IN THE MATTER Plan Change 50 (Queenstown Town Centre Zone
Extension) to the Queenstown Lakes District Plan

SUPPLEMENTARY EVIDENCE OF CLINTON BIRD

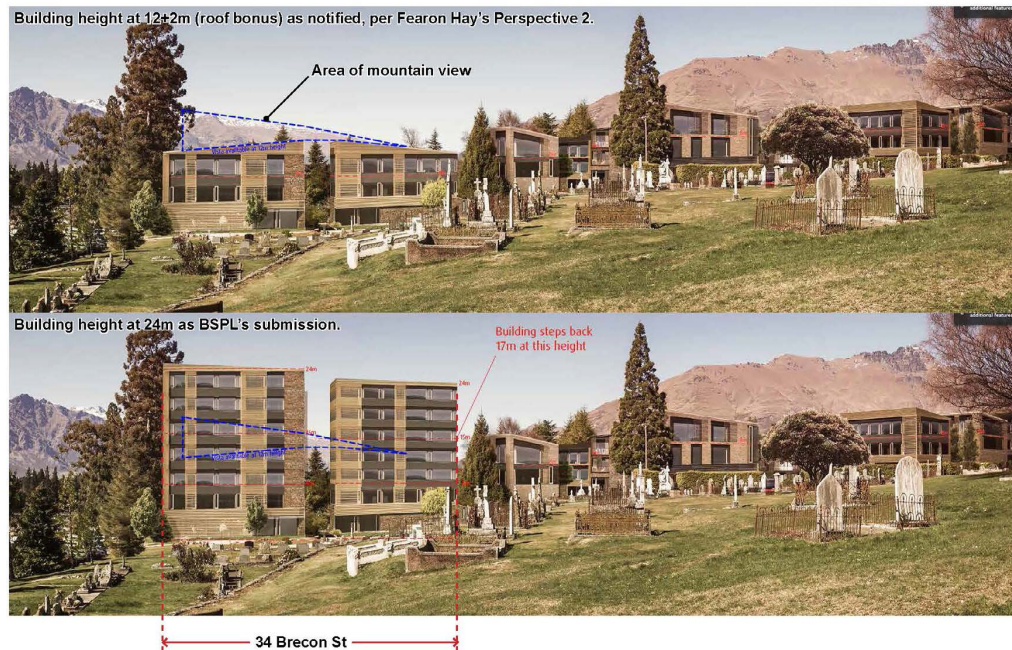
- 18.1 In comparing the 12m PC 50 building with the BSPL 24m high building on the Site, in relation to the cemetery, the 12m high building sits comfortably alongside the cemetery whereas the 24m high building (which is twice the height) begins to take visually dominant command of the cemetery in a manner that is out of proportion to its likely retail and 'permanent' or 'non-permanent' residential use. I am using the term '*visually dominant*' here not so much to infer that I or members of the general public would feel 'dominated' by the height of the building, but rather to describe the relationship between the height, scale and proportioning of the general mass/bulk of the building and its visual effects on the cemetery (see Figure 1).

- 18.2 In my opinion, the domination of the cemetery would arise as a result of the overt and disproportionate visual primacy, supremacy and prominence of the 24m high building, relative to the spatial setting of the cemetery within its local and greater Queenstown landscape.

- 18.3 The eye would be drawn relatively quickly across the cemetery in the foreground and the middle distance to focus on the building beyond.
- 18.4 Instead of experiencing a series of visually recessive 'low key', 12m high buildings blending into an overall scene in which all component elements (including landscape, grave headstones, buildings and/or trees) take on an approximately equal and harmonious, non-hierarchical visual prominence, the 24m high buildings stand out and apart from the other elements in the overall scene and command the attention of the eye. This is further reinforced by the vertical proportional emphasis of the 24m high buildings.

- 18.5 As visitors to the cemetery moved further down the slope towards Brecon Street (to the left of the image) the 24m high buildings would appear even higher, with the dominance effects described above becoming further accentuated.

- 18.6 The closer people visiting the cemetery moved towards the boundary between the cemetery and the Site, the greater the perception of dominance would be, largely because the building would appear taller and because people would experience a sense of encroaching on the private indoor and outdoor living realms of the building's occupants. That is why I recommended in my primary evidence that a road be constructed (as part of a land swap) between the cemetery and the Site. Roads have a well-established tradition of successfully mediating between public and private realms. Examples include roads with parks on one side and houses on the other, and roads around the edges of coastlines with the sea on one side and baches and/or farms on the other.

Figure 2: Right image: Shadows cast at 10.00am in mid-winter (21 June).

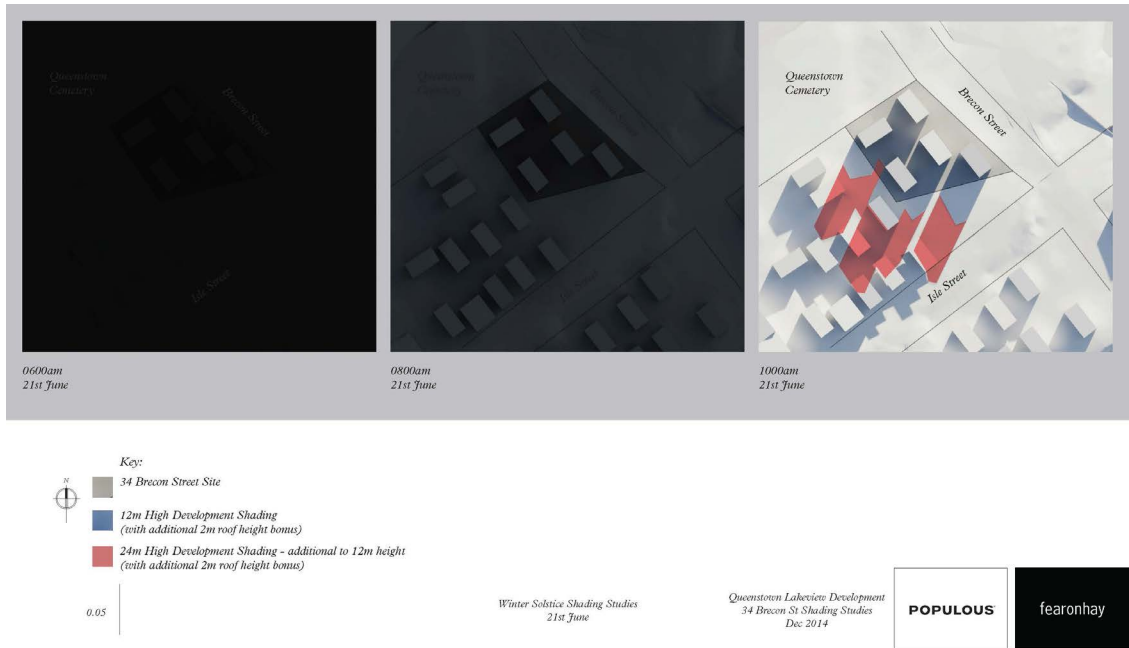
26. Figure 2 illustrates how 12m high buildings on the Brecon Street site would cast relatively short shadows onto the edge of the holiday park land within the Lakeview sub-zone, whereas 24m high buildings would cast very much longer shadows across this area, and over parts of Isle Street not affected by a 12m high building, thereby creating more than minor adverse shading effects.

Figure 3: Left image: Shadow cast at 12.00pm in mid-winter (21 June).

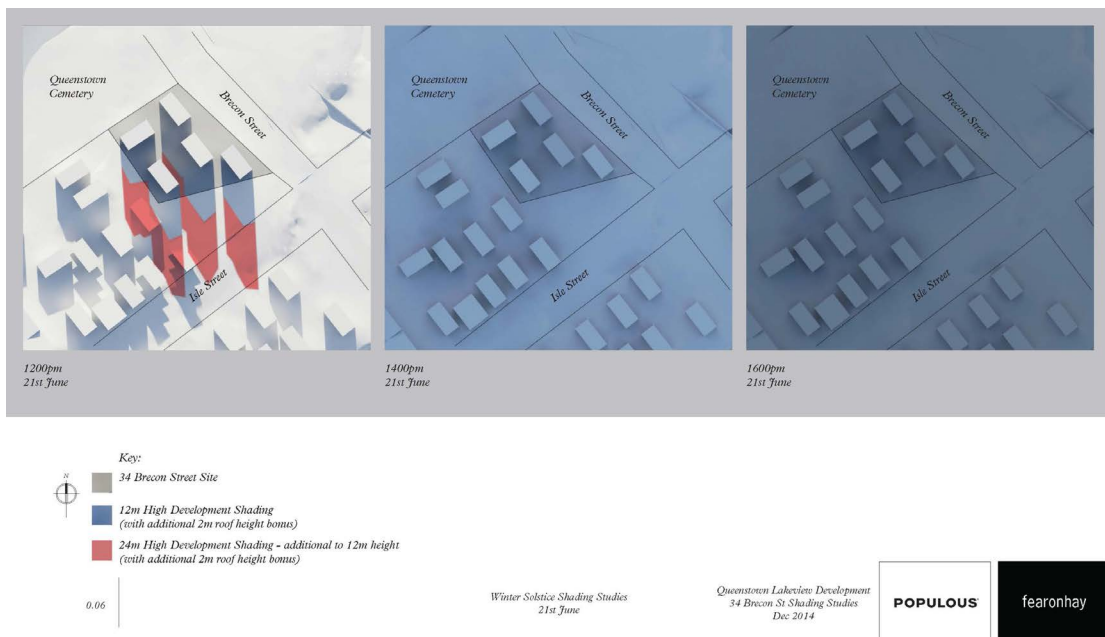
27. Figure 3 illustrates how shadows cast by 24m high buildings on the Brecon Street site would be over twice the length and extend far beyond those cast by 12m high buildings on the same site. Isle street would not be shaded by a 12m building but it would be by a 24m building high building.

Figure 4: Middle and right images: Shadows cast at 8.00am and 10.00am during one of the two Equinoxes (21 September)

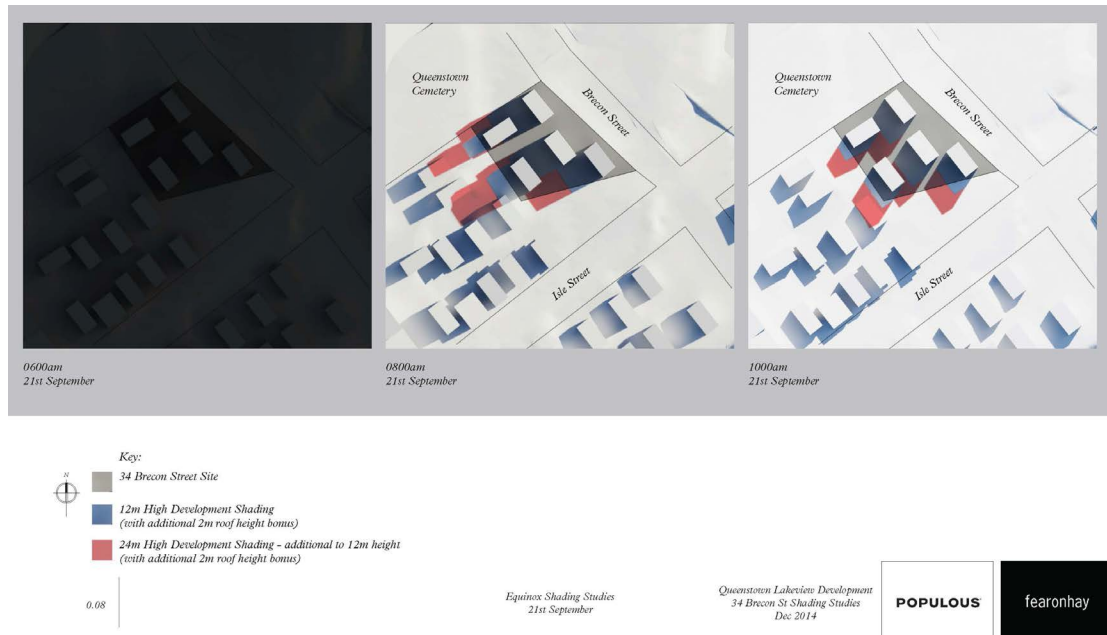
28. Figure 4 shows shadows cast by 24m high buildings to be well over twice the length of 12m high buildings, and giving rise to adverse effects on the holiday park land. At 10.00am shadows from 12m high buildings barely extend beyond the Site whereas those cast by 24m high buildings extend well beyond that boundary.

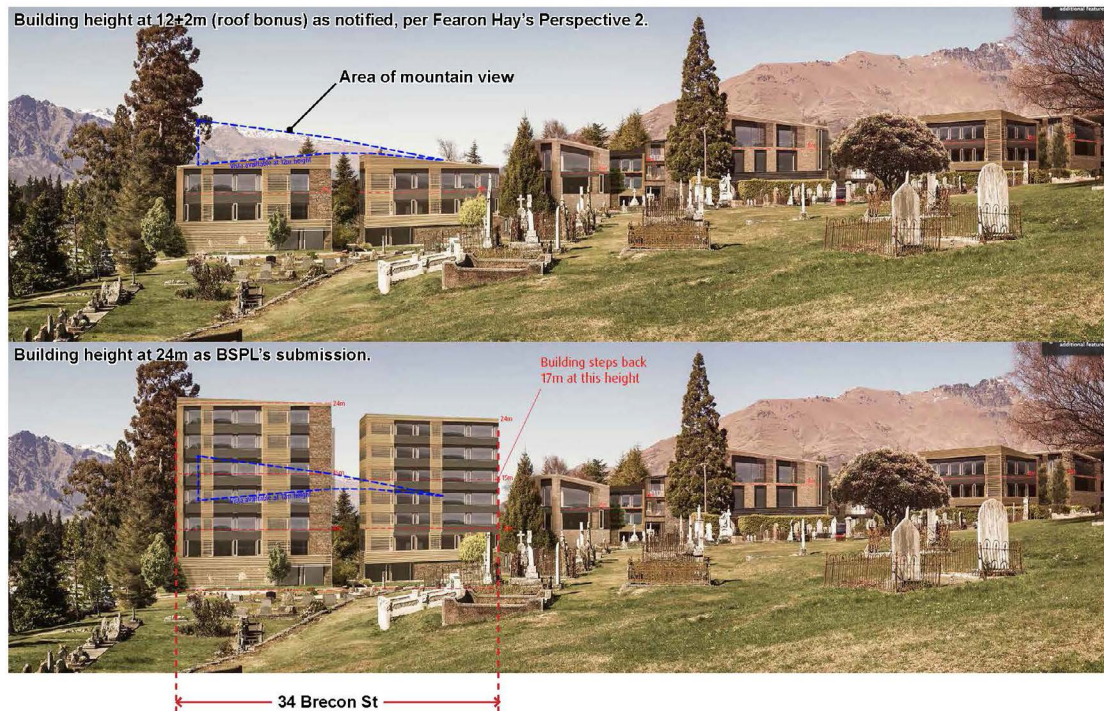
34. Mr Gibbs assessment of the difference in the effects of a 12m (plus the 2m roof bonus) and a 24m high building on views from the cemetery relies solely upon the small triangular "area of mountain view" (outlined in the blue dotted line) to substantiate his opinion that the loss of views is "insignificant". In this regard, Mr Gibbs concentrates almost exclusively on the *quantity* of the modified view rather than its *quality*.
35. In my opinion, Mr Gibbs has overlooked or chosen to ignore the following 'visual facts':
- 35.1 The existing view, and that which would exist under the PC50 12m high building scenario, demonstrates a virtually continuous and unimpeded natural silhouette against the sky comprised of trees and mountain range ridgelines. The 24m high building interrupt and disrupt with built form the continuity of the natural skyline;

- 35.2 No 12m high buildings encroach into the backdrop of the sky. The 24m high building penetrate significantly into and eclipse the backdrop of the sky;

- 35.3 The consistency in the heights of the 12m buildings above ground level ensures that they generally follow the slope of the underlying landform and step progressively down the slope from right to left, just as do the graves and headstones. In that sense the buildings and the graves/headstones are in visual synch and harmony with one another. The 24m high buildings, relative to the 12m high buildings to their right (west), run counter to and oppose the underlying natural topography which drops down in height towards Brecon Street, off to the left of the image; and

- 35.4 The 12m high buildings enable the large scale and grandeur of the Remarkables mountain range (on the left) and Cecil Peak (on the right) to remain fully legible and the predominant natural elements in the overall scene. By appearing to be taller than the Remarkables mountain range and obscuring much of them, the 24m high buildings visually distort and diminish their apparent scale and grandeur.

Figure 14: A photomontage from Viewpoint 8 approximately mid-way along the footpath on the lakeside edge of Queenstown Gardens, illustrating in red the visual bulk and effect of a 24m high building on the 34 Brecon Street site.

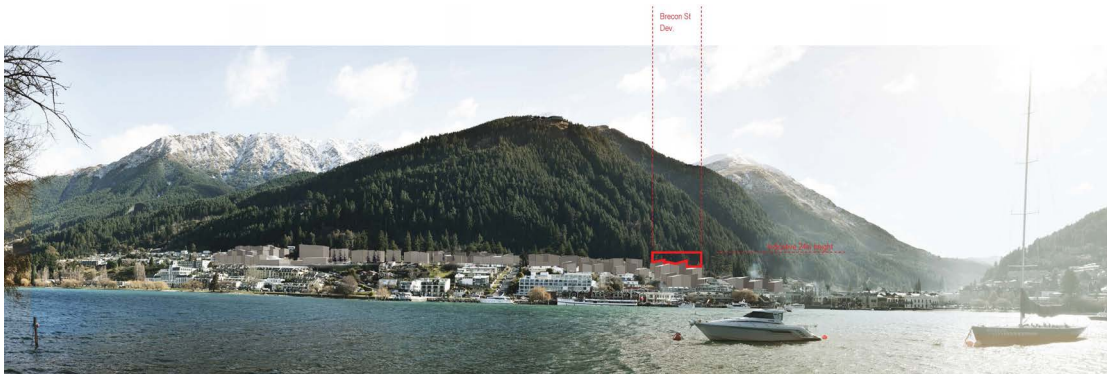
50. In my opinion, all three photomontages illustrate how doubling the height of a building on the 34 Brecon Street site, creates something of an abrupt and visually truncated right hand (eastern) end to the enabled development silhouette/profile of the

Lakeview and Isle Street sub-zones against the backdrop of the Ben Lomond Scenic Reserve. The PC50 height Limit Plan, as notified, would enable and be likely to deliver a visually legible gentle slope down from the tallest buildings on the left (west) of the images to the right (east) where the subzones merge with the low lying Gorge Road valley. In other words there would be a synchronicity between the sloping topography of the natural landform underlying the two sub-zones and the built form constructed on top of it. This would help to ensure that the character of the unique landform would remain legible.

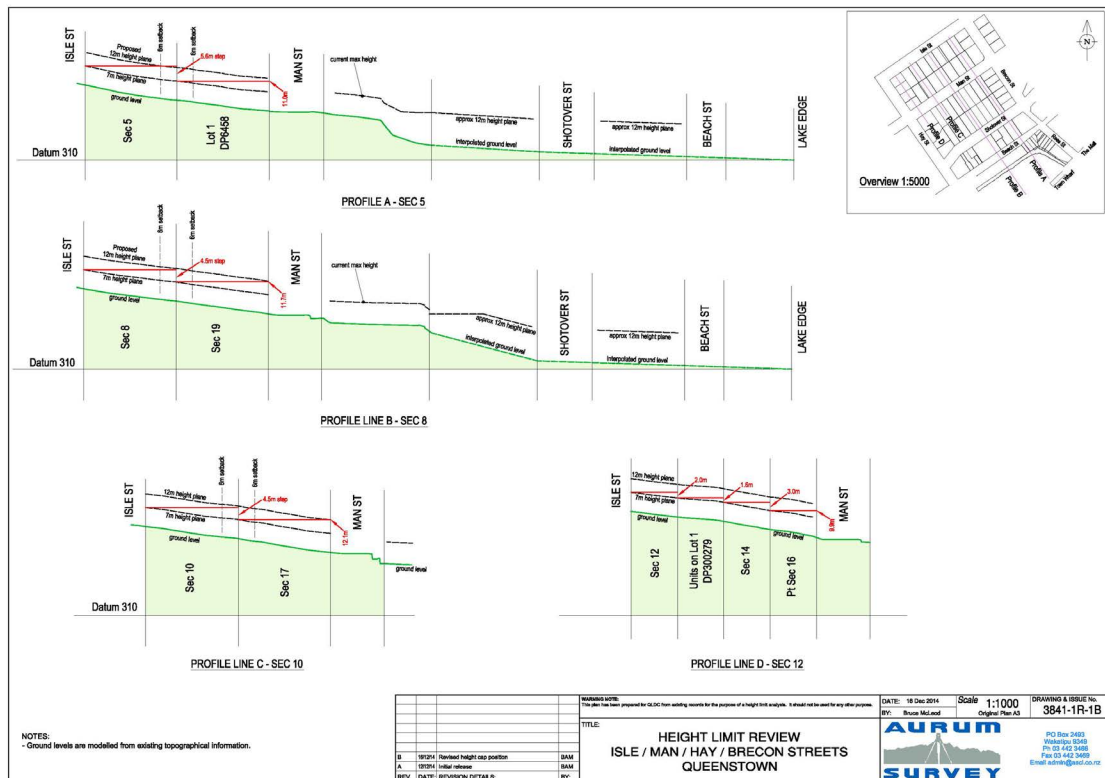
56. The effect of the proposed rule, as I understand it, is to create two stepped maximum building height envelopes between Isle Street and Man Street. One envelope would have, as its upper limit, a *horizontal* plane extending south-eastwards from a maximum height of 7m above the front (north-western) boundary with Isle Street to whatever height above ground level was reached at line set back 6m from the rear (south-eastern) boundary of the site. The second envelope would also have, as its upper limit, a *horizontal* plane extending from a point 7m above the rear (north-western) boundary of a Man street property to whatever height was reached at the front (south-eastern) boundary of the site.
57. Having considered the likely urban design outcome of this proposed rule, I do not support it for the following reasons:

- 57.1 Application of this rule would be likely to result in no stepping of building form *within* a site, and only two (disconnected) stepped forms across the entire north-west/south-east width of the block;

- 57.2 The rule is likely to result in an entire city block of flat roof buildings, two storeys high on the north-western edge of the block and three storeys high on the south-eastern edge;

- 57.3 A 7m maximum building height control on the Isle Street frontage would limit the street frontage of the building to a maximum of 2 storeys in height. Excavation could enable a third storey but the lowest of 3 storeys would have very little or no access to light from the street;

- 57.4 A maximum of two storeys on the street frontage is likely to privilege purely residential accommodation;
- 57.5 The rule would be likely to reduce the chances of achieving a mixed-use development outcome, with street edge-activating retail and/or commercial space at street level and two storeys of residential accommodation above;

- 57.6 An entire block of predominantly 2 and 3 storey high residential accommodation in the Isle Street block would result in a pocket of semi-suburban development interrupting the continuity of the desired extension of the existing town centre urban character and ambience through to the western end of the Lakeview sub-zone;

- 57.7 It is difficult to see how the rule would rule apply to the possible amalgamation of sites, especially a scenario where back-to-back sites (one or facing Isle Street and one or more facing Man Street) were amalgamated; and

- 57.8 Having different rules for the two Isle St blocks may result in inconsistent streetscape and an inconsistency in urban form within this sub-zone.
